Access Compliance Report

Public Rights-of-Way

Intersection ID: 31563	Main Street: DORIS_RAY_CT	Cross Street: MCCORD_ST	Location: NE
ADA ID: 2631A56D1F8A	Ramp Type: BlendTrans1	Initial Pass/Fail: Fail	Overall Compliance: No
		Severity Score: 10

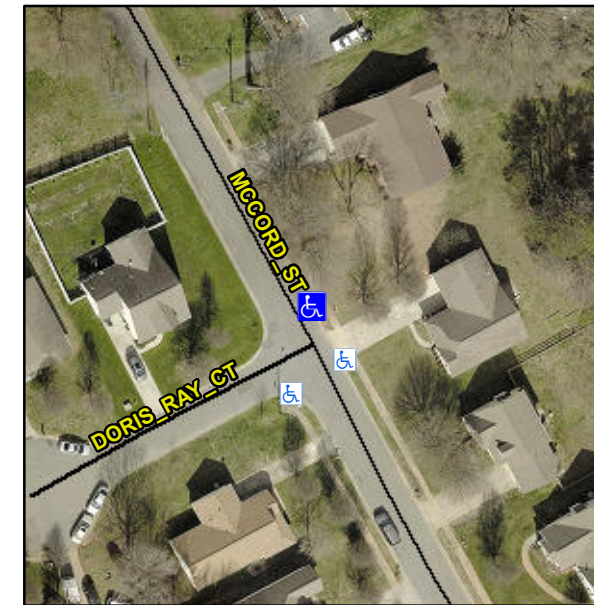
R304.5.1, R304.5.3

Compliance	Description	Data	Compliance	Description	Data
N/A	Ramp Length (in)	47.5	Yes	BlendTrans Slope (%)	3.3
No	Ramp Width (in)	41.5	No	BlendTrans XSlope (%)	2.1
N/A	Flare Type LT	N/A	N/A	Flare Type RT	N/A
N/A	Flare Slope LT (%)	N/A	N/A	Flare Slope RT (%)	N/A
N/A	Flare Traversable LT?	N/A	N/A	Flare Traversable RT?	N/A
N/A	Landing Length (in)	N/A	N/A	DWS Provided?	N/A
N/A	Landing Width (in)	N/A	N/A	DWS Contrast?	N/A
N/A	Landing Slope (%)	N/A	N/A	DWS Length (in)	N/A
N/A	Landing X Slope (%)	N/A	N/A	DWS Full Width?	N/A
N/A	Landing Curb? (Y/N)	N/A	N/A	DWS Offset (in)	N/A
N/A	Shared Landing?	N/A			
N/A	Gutter Ponding?	N/A	N/A	Gutter Slope (%)	N/A
N/A	Gutter Lip Ht (in)	3.0	N/A	Gutter X Slope (%)	N/A
N/A	Painted X Walk1?	No	N/A	Painted X Walk2?	N/A
	X Walk 1 Direction	To W		X Walk 2 Direction	N/A
	X Walk 1 Width (in)	N/A		X Walk 2 Width (in)	N/A
	X Walk 1 Slope (%)	1.6		X Walk 2 Slope (%)	N/A
	X Walk 1 X Slope (%)	1.7		X Walk 2 X Slope (%)	N/A

Remove & Replace Curb Ramp With Two New Directional Ramps or Equivalent.
